Agenda Item # 1 - HOLDOVER

SUB-002857-2024

Griffin Place Subdivision

GRIFFIN PLACE SUBDIVISION

DETAIL SITE PLAN

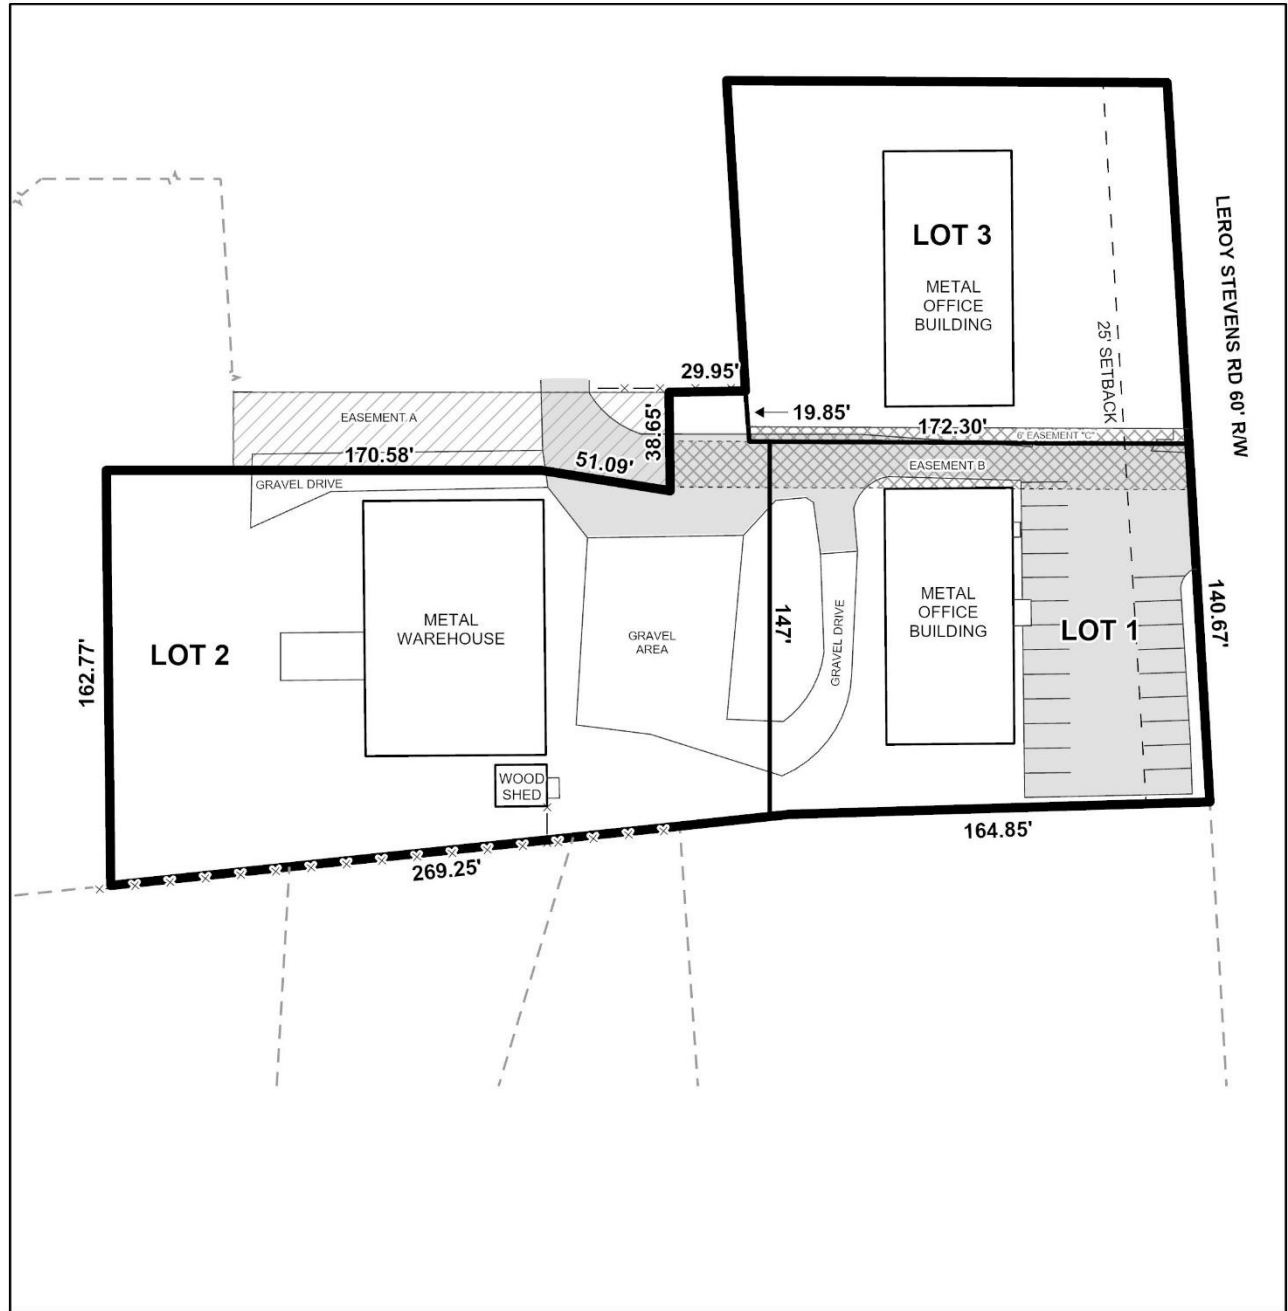
1. Revise the plat to illustrate ingress/egress easements that are at least 24 feet in width; or
2. Revise the plat to depict a flag lot that would allow proposed Lot 2 to have frontage on Leroy Stevens Road.

The application has been modified to create three (3) legal lots of record from two (2) neighboring metes-and-bounds parcels instead of two (2) legal lots from one (1) metes-and-bounds parcel. The adjoining property to the North has been incorporated into the request to facilitate an adequate 24±-foot wide easement that will provide access to Lot 2 from Leroy Stevens Road.

Proposed Lot 2 has been redesigned as a flag-shaped lot with a 25-foot wide "pole" providing frontage to Leroy Stevens Road. Such lot designs are discouraged by Section 6.C.9.(b) of the Subdivision Regulations unless similarly shaped lots are common within the vicinity of the subject site, or where unusual circumstances exist. The proposed lots are developed and make it difficult for Lot 2 to have adequate street frontage, which is a requirement of Section 6.C.4. of the Subdivision Regulations; therefore, a flag-shaped lot appears to be the most appropriate lot design to facilitate compliance with Section 6.C.4. such that a waiver of Section 6.C.9.(b) may be appropriate.

It should be noted that access to Lot 2 is facilitated by an easement centrally located between all three (3) lots. As such, Lot 2 will not be accessed by the "pole" of the proposed flag-shaped lot, part of which is developed with a parking lot for use by the development on Lot 1.

While Lots 1 and 3 appear to comply with off-street parking requirements, approval of the subdivision would create a non-conforming condition on Lot 2 in that it does not have a parking lot to accommodate parking for the warehouse use. As such, further development of Lot 2 would be subject to the Non-Conforming provisions of Article 6 of the UDC.

- B. Add a note to the SUBDIVISION PLAT stating that as shown on the 1984 aerial photo (FLIGHT 16 - #78) LOTS 1 and 2 will receive historical credit of existing (1984) impervious area towards stormwater detention requirement per Mobile City Code, Chapter 17, Storm Water Management and Flood Control) as follows: LOT 1 – 21,000 sf AND LOT 2 – 8,500 sf.

- D. Add a note that all easements shall remain in effect until vacated through the proper Vacation process.
- E. Revise NOTE #11 to read “ALL EXISTING AND PROPOSED...” instead of “ALL PROPOSED...”.

Revised for the June 20th meeting: The existing arrangement will work for Fire if the stated gravel drive on Lot 2 is updated to follow the guidance of the Fire Code for an alternate hammerhead, see Appendix D Figure D103.1 of the 2021 IFC.

1. Retention of the 60-foot right-of-way along Leroy Stevens Road on the Final Plat;
2. Retention of the lot sizes in both square feet and acres in a table on the Final Plat;
3. Retention of the 25-foot front yard setback where each lot is at least 60 feet in width, per Article 2, Section 64-2-13.E. of the Unified Development Code;
4. Retention of a note on the Final Plat stating no structure shall be constructed or placed within any easement without the permission of the easement holder;
5. Compliance with all Engineering comments noted in this staff report;
6. Placement of a note on the Final Plat stating the Traffic Engineering comments noted in this staff report;
7. Compliance with all Urban Forestry comments noted in this staff report; and
8. Compliance with all Fire Department comments noted in this staff report.
